SUNDRY NOTICES AND REPORTS ON WELLS

Marcel BMM Federal 1-H

SUNDRY DATED SEPT 17, 2011

Marcel BMM Federal #1H
Yates Petroleum Corporation
30-015-36845
Sep 27, 2011
Conditions of Approval

WELL: MARCEL BMM FEDERAL #1 H
YATES PETROLEUM CORP

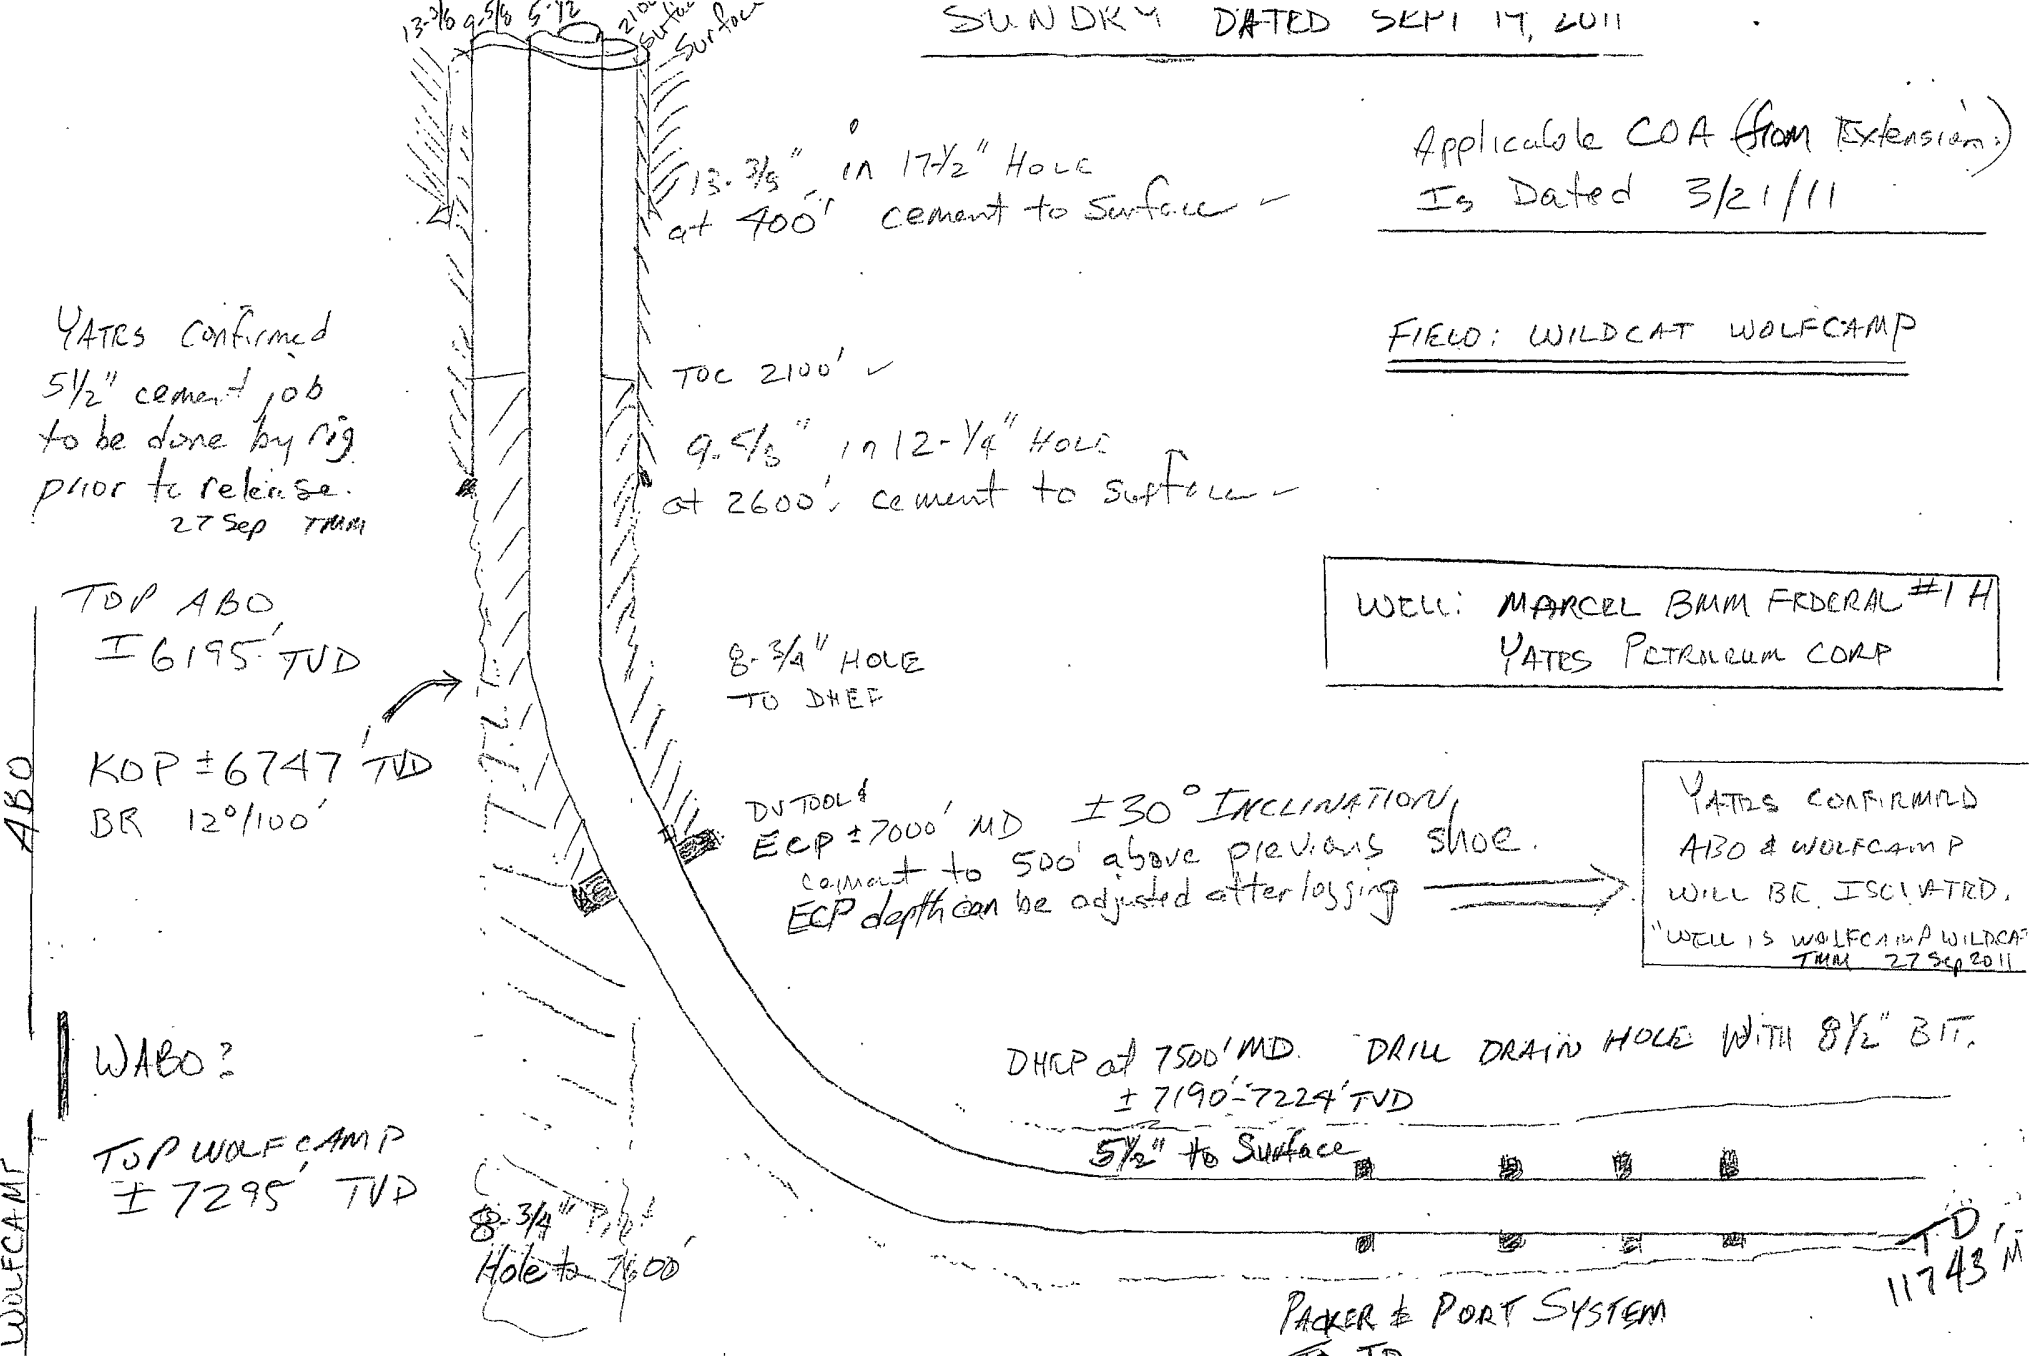
YATES CONFIRMED
ABO & WOLFCAMP
WILL BE ISOLATED.
WELL IS WOLFCAMP WILDCAT
TMM 27 Sep 2011

YATES confirmed
5 1/2" cement job
to be done by rig
prior to release.
27 Sep TMM

DUTTOOL
ECP ± 7000' MD ± 30° INCLINATION
cement to 500' above previous shoe.
ECP depth can be adjusted after logging

WABO?

1. COA previously approved with Extension on 21 March 2011 is still applicable.
2. Cement volume for the 13-3/8" surface casing may require increasing, since BLM volume check indicates only 13% excess is provided in the initial design.

5. **8-3/4" Pilot Hole:** Pilot Hole plugs shall include cement placed at the Top Wolfcamp, per BLM guidelines for Plugging.
6. If two plugs are set, the BLM is to be contacted (575 393-3612) at least 4 hours in advance prior to the tag of bottom plug. In accordance with Onshore Order 2.III.G.9, the interval between the two plugs shall be filled with mud of sufficient density to exert hydrostatic pressure exceeding the greatest formation pressure encountered while drilling such interval. Operator has the option to set one plug from bottom of pilot hole to kick-off point, and save the WOC time for tagging the first plug.

7. No more than 2000' is allowed between open hole-cement plugs in the pilot hole.
8. Operator to provide method of confirming TOC for the 5-1/2" Production Casing at 500' above previous casing shoe. Report TOC depth to BLM office.
